RE: Comments on the Tetra Tech, Inc. report (Oct. 21, 2015): "Upper Elk River: Technical Analysis for Sediment" and the "Draft Action Plan for the Upper Elk River Sediment TMDL"

**Analysis of the Drainage Density Assumption in the Elk River TMDL Documents**

Figure 1. GDRCo's field mapped channel heads from 14 THP units in McCloud Creek.

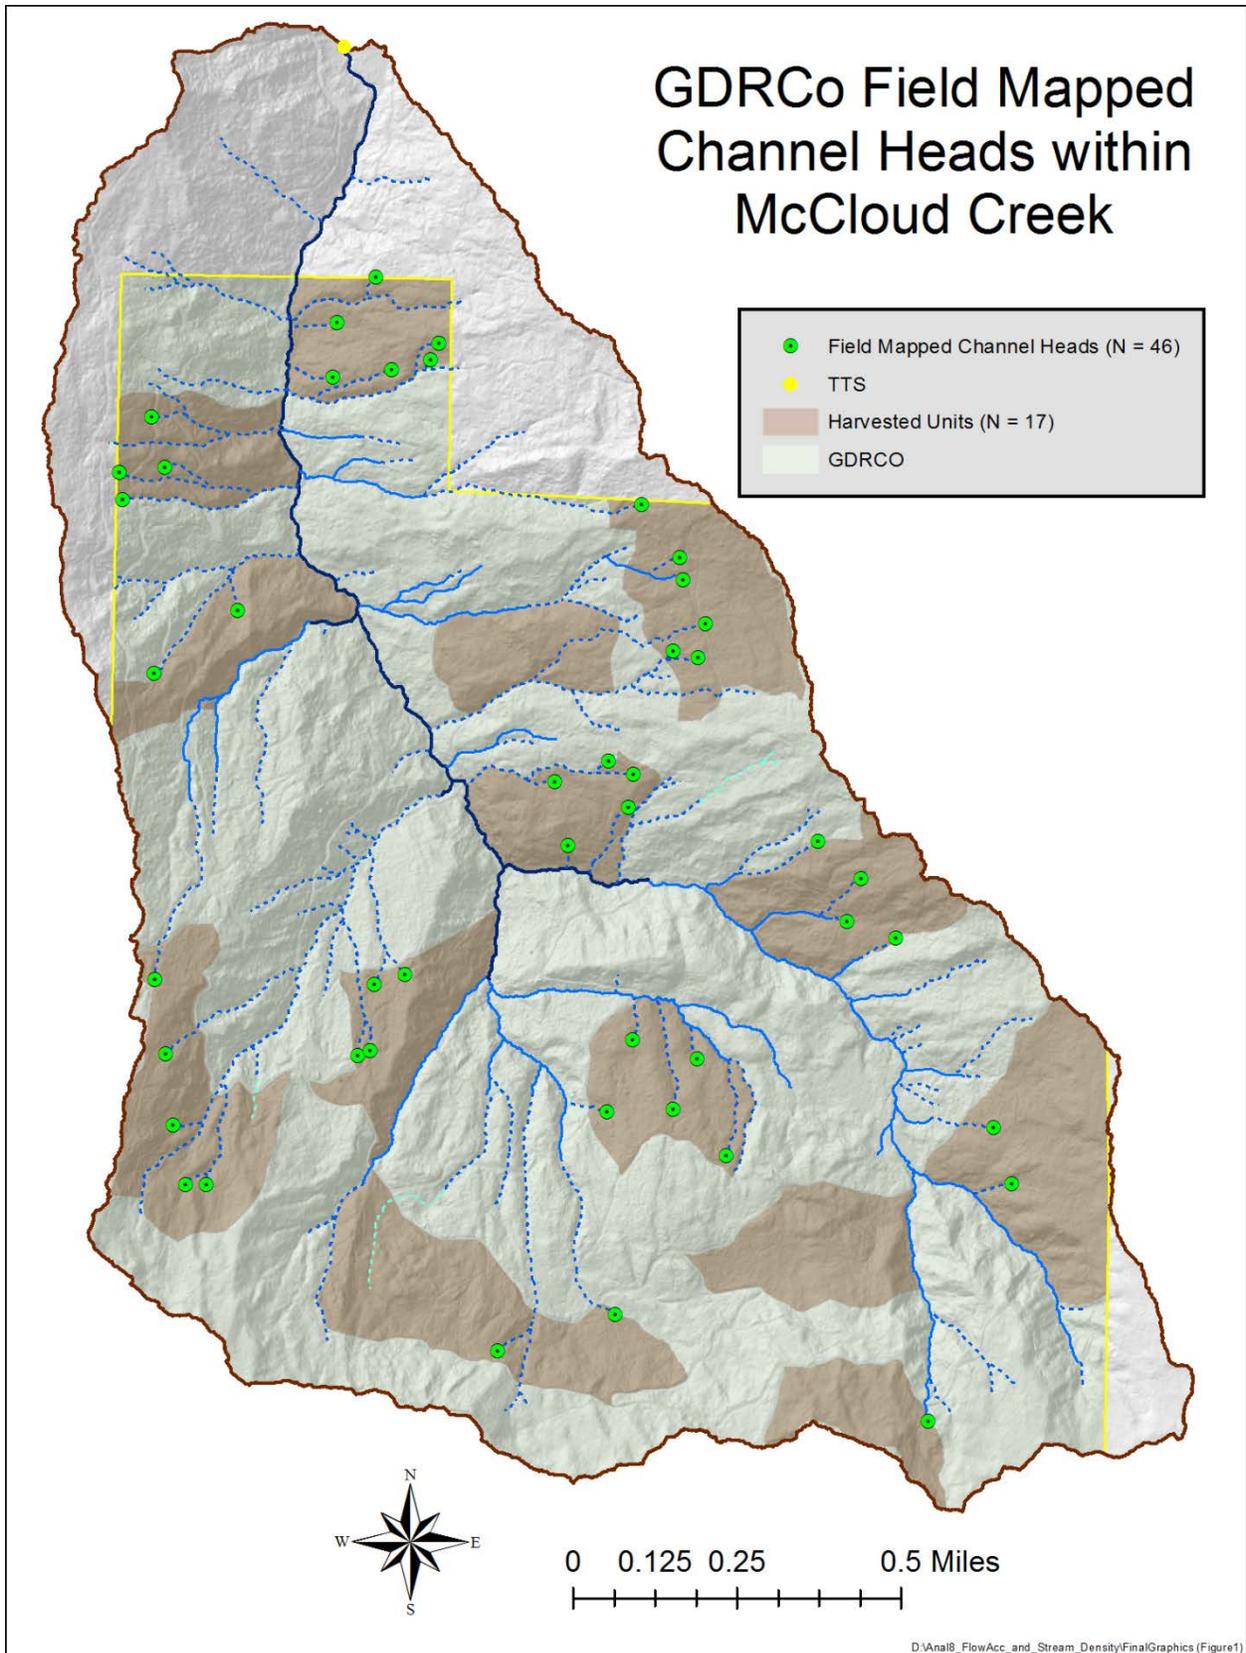
GDRCo further evaluated the validity of the contributing area approach presented in Buffleben (2009) to derive managed versus unmanaged drainage densities by utilizing field based channel mapping that was conducted for timber harvest plan layout within the McCloud Creek basin. McCloud Creek is a 2.37 mi<sup>2</sup> watershed and GDRCo owns approximately 85% of the basin. In 2006, GDRCo was issued WDRs for its operations in S.F. Elk River including McCloud Creek. Since 2006, GDRCo laid out 17 THP units within the McCloud Creek catchment that included 46 channel heads that terminated either within or adjacent to the THP boundary (Figure 1). Since these channel heads were within a THP boundary they were guaranteed to be field verified by an RPF and a high proportion received confirmation by state agency representatives during the Pre-Harvest Inspection process for THP approval to ensure no watercourses were missed and to verify the terminus of the channel head (e.g. top of the Class III channel). A GIS analysis was conducted to calculate the contributing area for each channel head location. The summary results for the two managed basins from Buffleben (2009) were included with the McCloud Creek data for comparison (Table 1). The drainage areas for the channel heads in McCloud Creek is highly positively skewed (Figure 2). Based on the range, median and average presented for the data in Buffleben (2009) we assume the data for all three study basins were also highly positively skewed (Table 1). GDRCo's actual field mapped drainage density is 9.41 mi/mi<sup>2</sup>. If GDRCo was to derive the stream layer using the contributing area methodology with the median drainage area (0.258 ha), the resulting drainage density would be 26.28 mi/mi<sup>2</sup>, 2.8 times higher than reality (Figure 3). For illustration purposes GDRCo also developed the hypothetical drainage network for McCloud Creek using the 0.52 ha as was applied in the Elk River Sediment Source Analysis and compared it to GDRCo's field mapped drainage network (Figure 4). The resulting stream density was 18.86 mi/mi<sup>2</sup> which overestimates the actual field mapped stream density by 100%. All the watercourses shown in yellow in Figure 4 are fictitious streams that amount to an extra 22.4 miles of channels that do not exist on the landscape. The implications of this is that Elk River Sediment Source Analysis attributes management related sediment from deep seated landslides, low order channel incision, bank erosion, and streamside landslides to these nonexistent channels.

Figure 2. Histogram and cumulative distribution of drainage area above the 46 field mapped channel heads from 17 THP units in McCloud Creek. Bins are in units of m<sup>2</sup>.

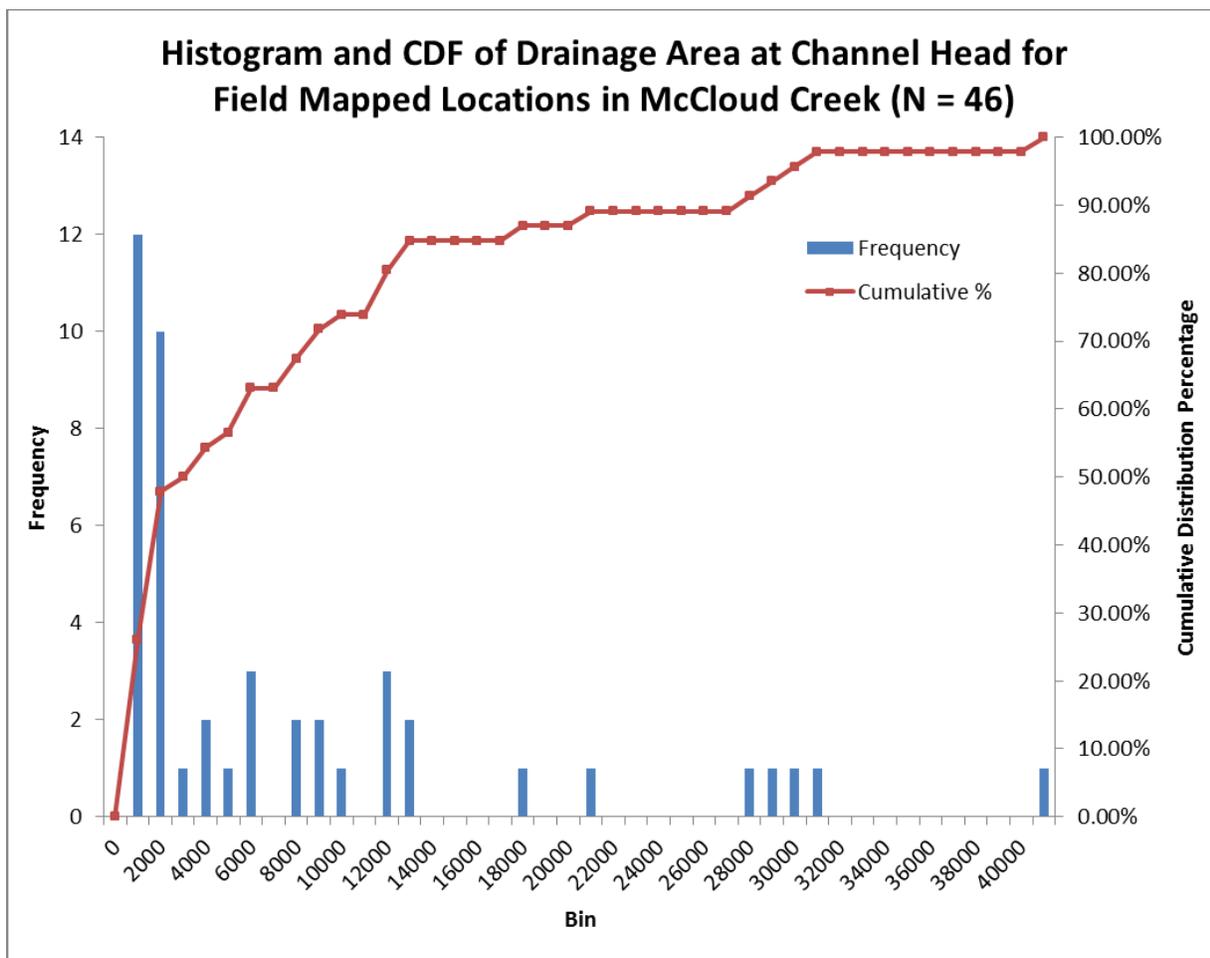
As mentioned above, the Elk River Sediment Source Analysis assumes that the managed drainage density is 16.5 mi/mi<sup>2</sup>. With such highly skewed data and with drainage areas of channel heads that span multiple orders of magnitude, it is inappropriate to use simple descriptive statistics such as average, median, or mode and expect to derive a realistic watercourse network that represents field conditions. Utilizing the median and average, for example, creates fictitious watercourse channels that do not exist on the landscape which the Elk River Sediment Source Analysis assumes are present and asserts are causing and delivering sediment to the Lower Elk River.

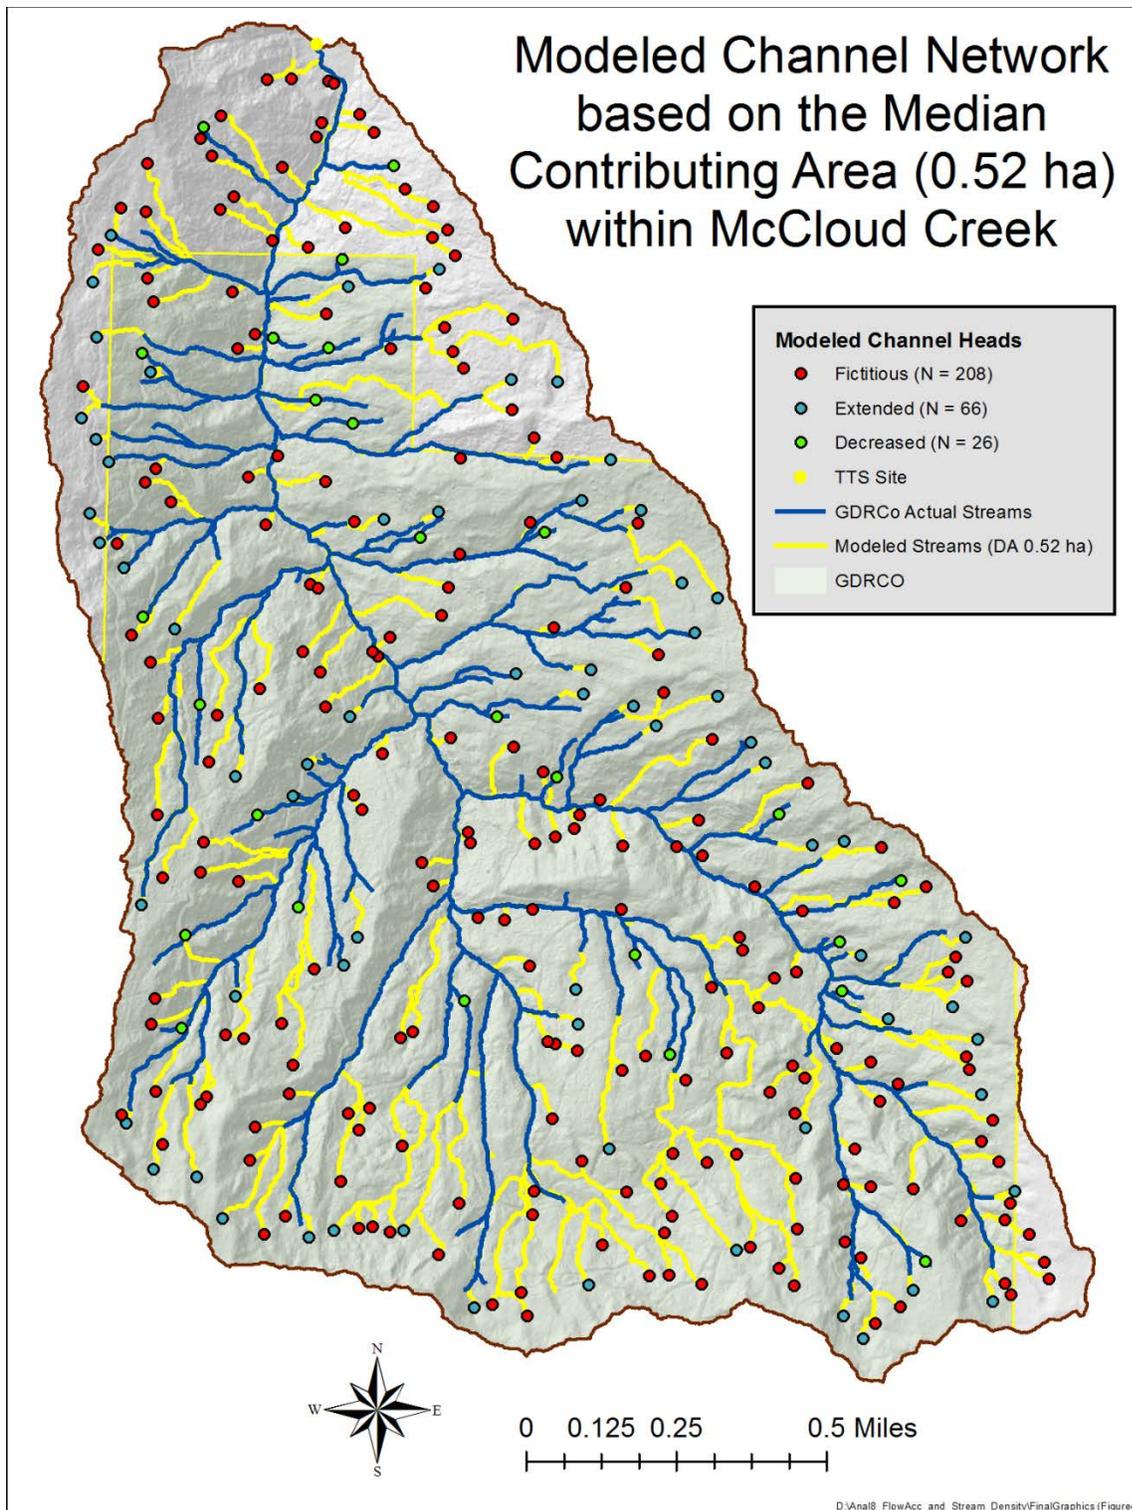
It is interesting that GDRCo's and HRC's independent drainage density estimates that were derived from LiDAR and field mapping differed by only 6%. Even if we were to assume that all the watercourses in GDRCo's McCloud Creek had extended due to headward incision from early logging practices by 100 feet, the drainage density would have been 8.51 mi/mi<sup>2</sup> (potentially a realistic unmanaged drainage density). This illustrates how the attempt by Water Board staff to account for the potential effect of early logging practice impacts on the watercourse network has resulted in a gross overestimate of the management related sediment inputs to Elk River.
